### **Gemini Project (APP0043095): Notification of Change**

This notice is provided to the Department of Environment and Science (the Department) on behalf of the applicant, Magnetic South Pty Ltd (**Magnetic South**), pursuant to s132(1)(a) of the *Environment Protection Act 1994 (EP Act)* to outline changes made to the layout of the proposed Gemini Project (the **Project**), since the application was originally submitted on 23 October 2019.

Figure 1 Original Project Layout

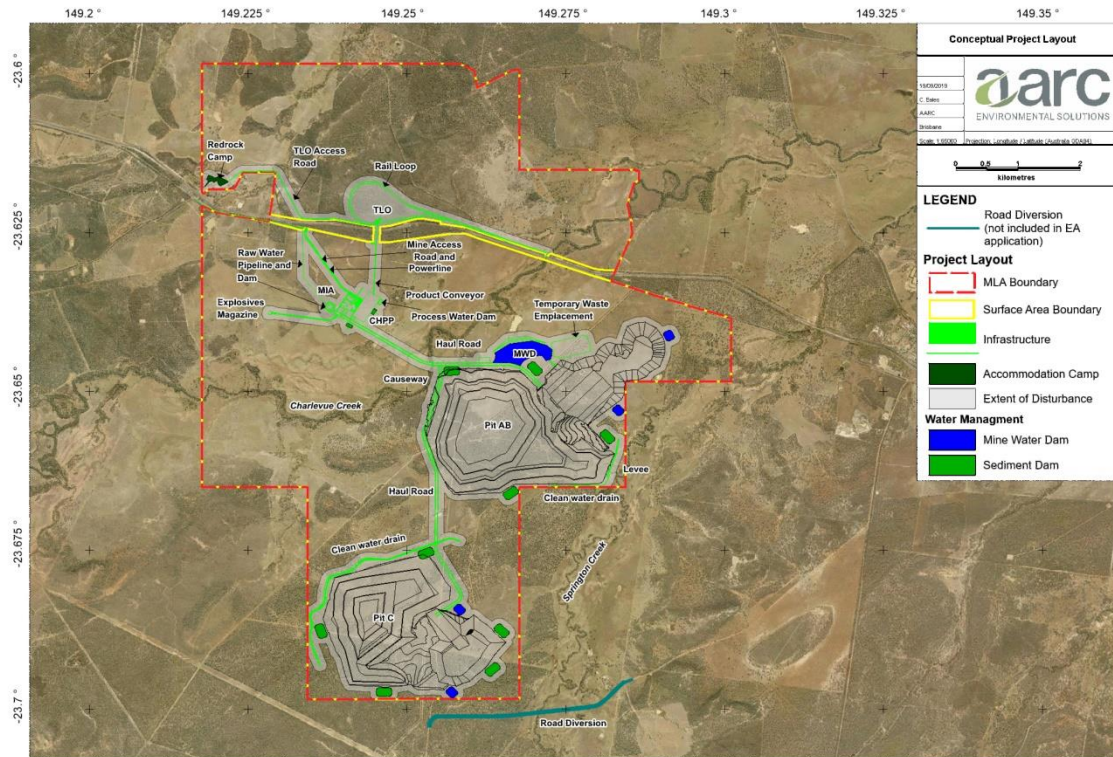
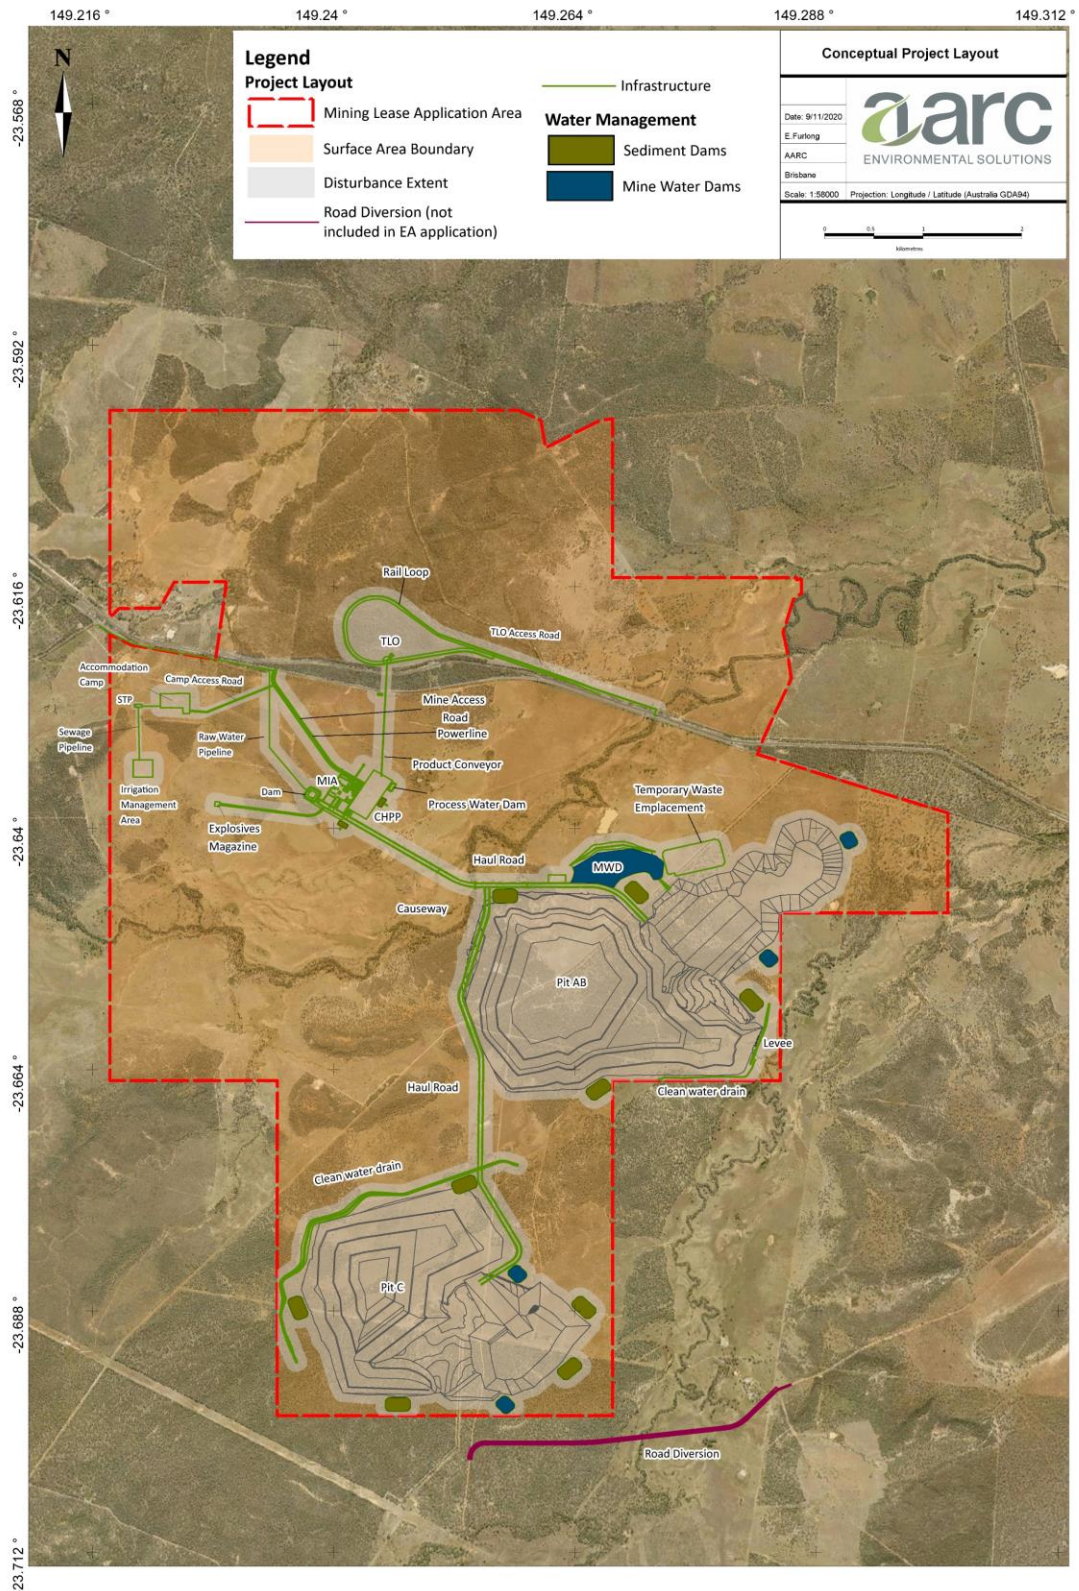
Changes to the general layout of the Project have been made in response to further investigation of site conditions, environmental assessments, and landholder submissions during the notification stage. The original Project layout is provided in the attached Figure 1, with the changed layout attached as Figure 2. The changes contribute to a reduction in the Project's disturbance area from 1961.2 ha in the original application to 1953.5 ha with the revised layout.

The original application proposed that the workers' accommodation and associated infrastructure (camp access road, sewage treatment plant, sewage pipeline and effluent irrigation management area) would be located on Lot 100 on RP882349 (**Redrock Park**), accessed via the public Redrock Park and Pine Grove Roads. This property is not owned by Magnetic South, and is located on the northern side of the Capricorn Highway.

The changed layout locates the camp and associated infrastructure to the south of the Capricorn Highway, on Lot 4 on RP801280 and Lot 1 on HT424, accessed via the main mine access road. Both of these properties are owned by Magnetic South.

The original application included a train loadout (**TLO**) access road approaching the TLO from the west, via Redrock Park, along with another access from the east via the intersection of Red Hill Road and the Capricorn Highway.

Whilst Magnetic South does not concede that the submission by the owner of Redrock Park accurately outlines the likely impact of the proposed activities, to address the concerns identified in the submission regarding potential noise, dust and traffic impacts, the western TLO access road has also been removed from the Redrock Park Property. All access to the TLO will now be via the eastern Red Hill Road access, reducing or removing the potential impacts from dust, noise and traffic on the Redrock Park residence and accommodation facility. Removal of one of the TLO access roads naturally reduces the disturbance footprint of the Project.
